Response to Reviewer 2

The authors made a remarkable work to update the current state-of-the-art Antarctic SMB observational dataset, including SMB observations at different temporal resolution and covering different time period, with quality control. This dataset is unique and crucial for evaluating atmospheric models, in the absence of reliable precipitation observations in Antarctica. It is all the more important than SMB is driving the interannual variability of Antarctic ice sheet mass change and that its evolution under climate change is still highly uncertain, with potential significant contribution to sea level change during the 21st century. In this context, observational reference needed to improve the representation of SMB in atmospheric models is of much value for the whole earth system community.

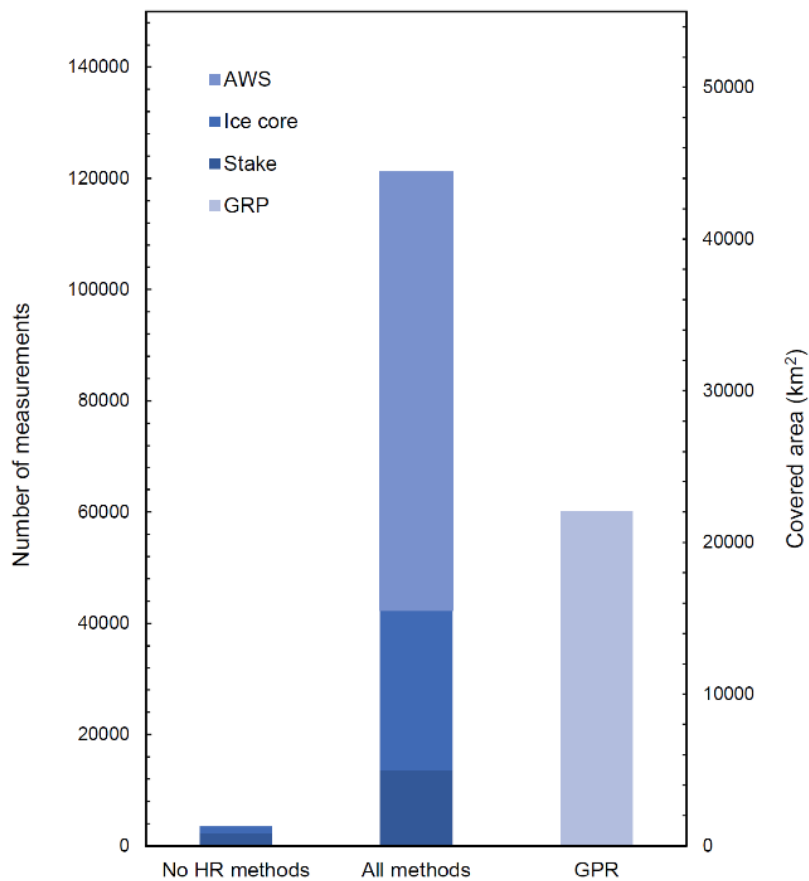
- p1 L14: "268913 individual multi-year averaged observations"
- p3 L76-78: "175373 individual GPR measurements"
- p7 L193-194: "including 265334 unique measurements by radar isochrones,"
- p11 L318-319 "Finally, 191816 multi-year averaged observations are left for model-observation comparison."
- p7 L194-198: "The majority of these observations (~ 69%) are derived from

airborne snow radar measurements in the coastal zone of West Antarctica and Antarctic Peninsula, Ronne Ice Shelf, South Pole, Pine Island and Thwaites glaciers (Medley et al., 2013; Medley et al., 2014; Dattler et al., 2019). GPR data from two transects in East Antarctica account for 30% of all measurements in this subdataset." + Figure 2

I think it's not fair to compare stakes numbers with GPR numbers. It makes more sense to compare the areas covered, e.g. using a 1km x 1km grid or a 10km x 10 km grid (number of pixels covered)

According to the above calculation, changes have been made accordingly for the number occurring in these lines. Also, we have re-drawn Figure 2. Following is the current Figure 2.

We agree with you, and in the revised version, the GPR covered areas are calculated using 1km×1km grid. Changes have been made accordingly in the text.

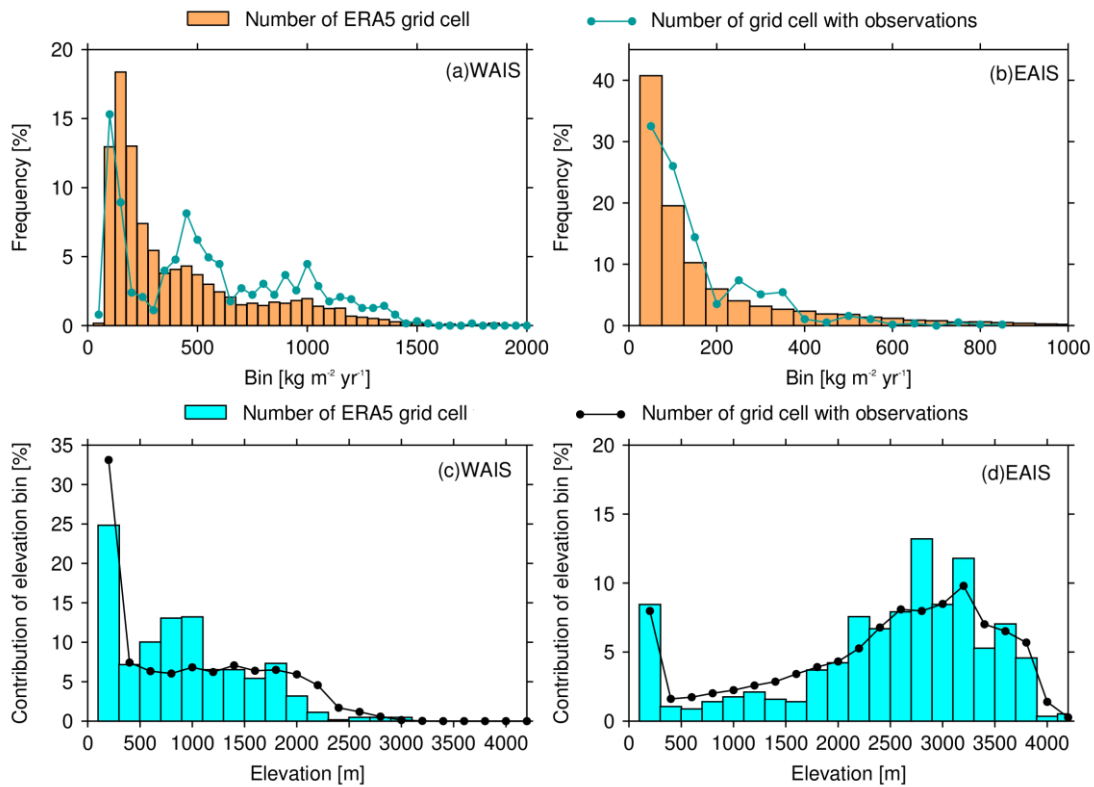
- p11 L342-344 "A comparison of the density distribution of ERA5 precipitation minus evaporation (P-E) with the filtered multi-year averaged SMB observations reveals that the multi-year averaged dataset is representative of the entire P-E spectrum of the model at the continental scale (Fig.6a)."

Are the histograms for observed multi-year SMB including individual GPR points and other kind of data? As stated above, I think it's not fair to compare the number of GPR points with other kind of data, so the histogram might be biased with GPR datapoint numbers.

I suggest to (1) bin GPR data (2) differentiate GPR data from other data in the histograms.

Looking at Fig.1c), one can also see that low-elevation datapoints are from GPR and are concentrated on WAIS. I suggest you separate Fig 6 into WAIS and EAIS to discuss the difference of coverage between the 2 basins, and change the conclusion accordingly.

In the histograms, all the multi-year averaged SMB observations during the 20th century are used. We firstly calculate the averaged SMB for each 30×30 km grid cell (values from points located in the same grid cell are averaged). ERA5 fields are also bilinearly interpolated over a 30 km Cartesian grid. The 30 km grid is chosen due to the spatial resolution of ERA5 (~31km). Then we compare the contribution (relative frequency) of each bin (50 kgm⁻² yr⁻¹ wide) to total SMB. Lastly, we estimate the representativeness of elevation area distribution of SMB observations by the comparison between the contribution of areas with measurements in each 200 elevation bin, and those from ERA5 SMB field. In a word, here we bin all multi-year SMB observations using a 30×30 km grid, and thus, we do not compare the GPR number with the other kind of data.

Thanks for your good advice. Following your advice, we discuss if the AntSMB dataset is representative of P-E spectrum of the model over the WAIS and EAIS, respectively. Following is the re-drawn Fig. 6. Corresponding changes have been made in the text.

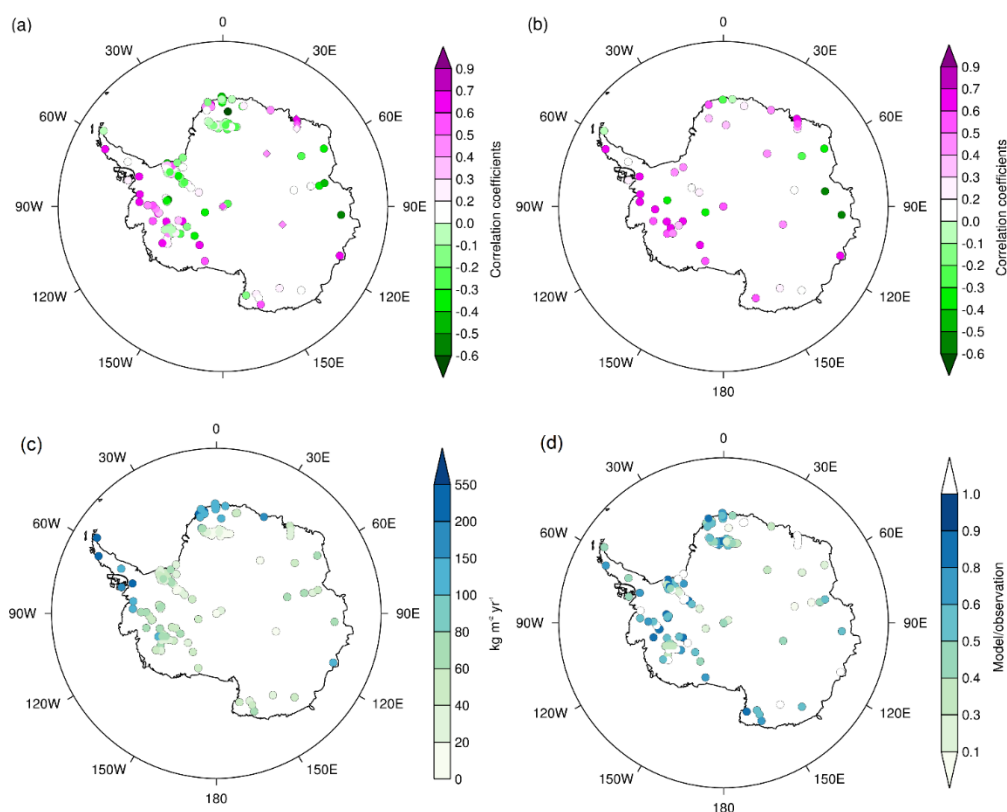
→ Can you separate ice cores and other data to assess if there is a real problem specifically with SMB interannual variability in ice cores? It is of importance as annual SMB observation from ice cores have been used to create the widely-used SMB reconstruction from Medley and Thomas (2019).

→ Can you also check for interannual variability (std of annual values) : ice cores vs. other observations vs. ERA5?

As shown in the following Figure 5 of the current version, we separate ice cores from other types of measurements. The corresponding changes have been made in the text.

In current version, the comparison of interannual variability in SMB between ice core/other observations with ERA5 for their overlapping period have been added.

Figure 8: Cumulative daily snow accumulation and snowfall over time for each

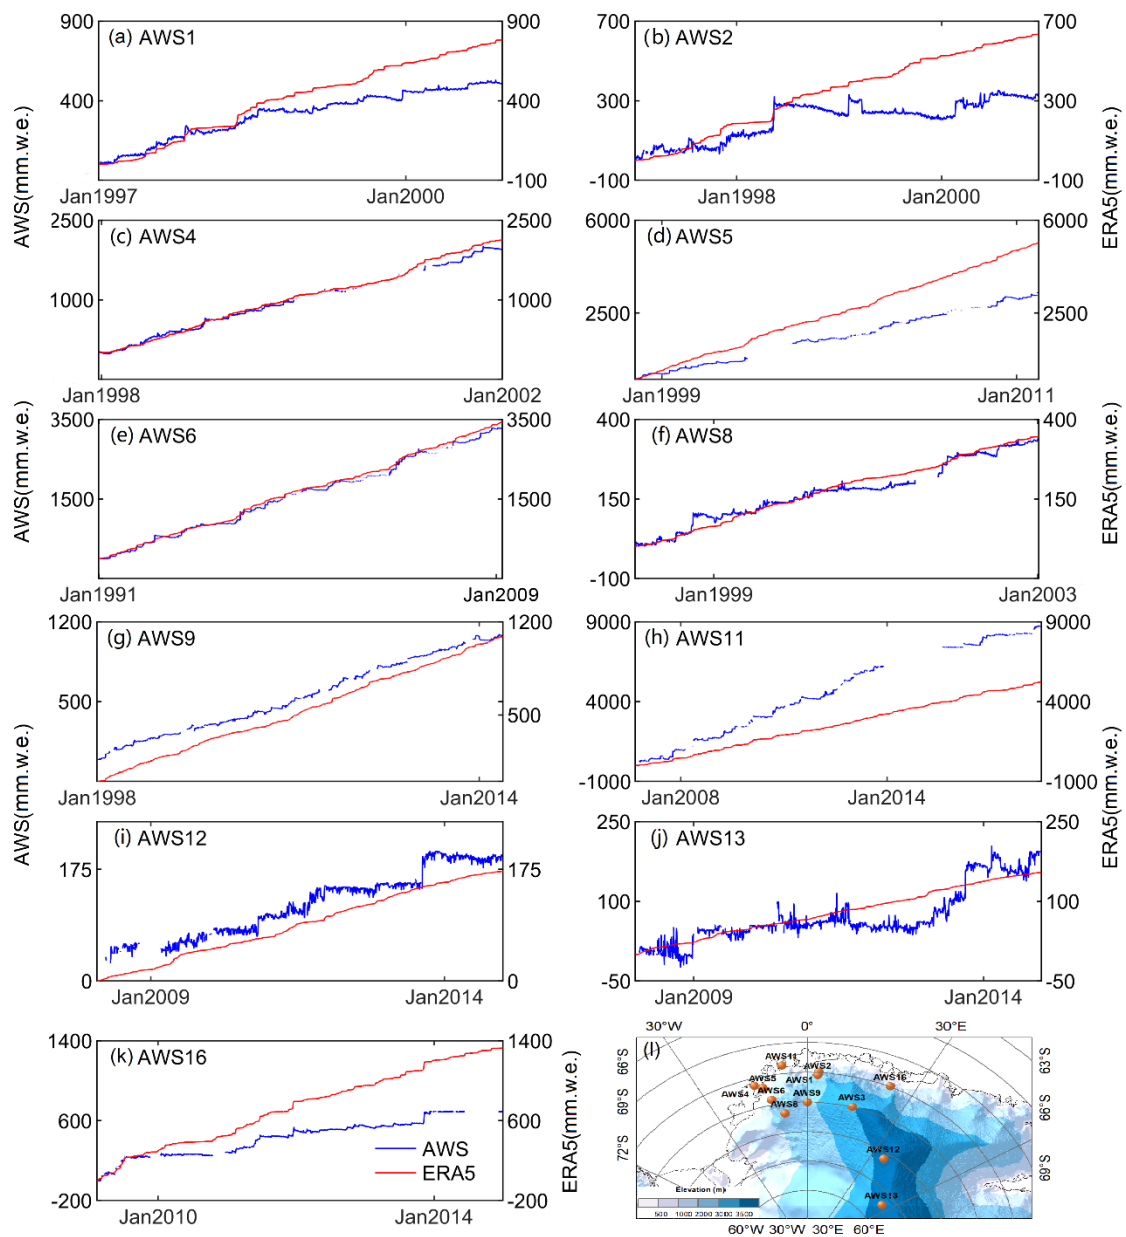
→ You should add a comparison with AWS, at least at some key sites, to assess the usefulness of this dataset.

Liu et al. (2019) used AWS snow accumulation observations included in our AntSMB dataset over the Ross Ice Shelf, and inland East Antarctic Plateau to estimate the performance of ERA5 on the synoptic scale. To avoid repetition, we have added a comparison between ERA5 outputs and AWS observations over the Dronning Maud Land. They are as follows.

“A recent study showed that ERA5 present relatively good skills for representing snow accumulation changes on the synoptic timescale, observed at the AWSs over the Ross Ice Shelf and along the traverse route from Zhongshan Station to Dome A, with 56%~88% of extreme snowfall events captured (Liu et al., 2019). Given that these AWS observations are included in our AntSMB dataset, to avoid repetition, here we make a comparison between cumulative daily snowfall from ERA5 and the corresponding accumulation records from 11 AWS observations over the DML (Fig. 8). Obviously, gaps in the AWS records occur in most stations because of the problems of sensors or data transmission. Snow accumulation decreases in the daily cumulative AWS records, and reflects the important role of drifting snow,

compaction, sublimation or even ablation in the accumulation changes. Despite the noises of these post-deposition processes, stepped increase are observed for both ERA5 snowfall and AWS snow accumulation at each station in Fig. 8. Furthermore, the occurrence of large snowfall events are in broad agreement with the corresponding large accumulation events at all stations. These suggest in spite of the limits of AWS measurements due to the complex impacts of post-deposition noises, they are an important source of ground-based measurements for evaluating synoptic changes in the precipitation from reanalysis products or climate models.”
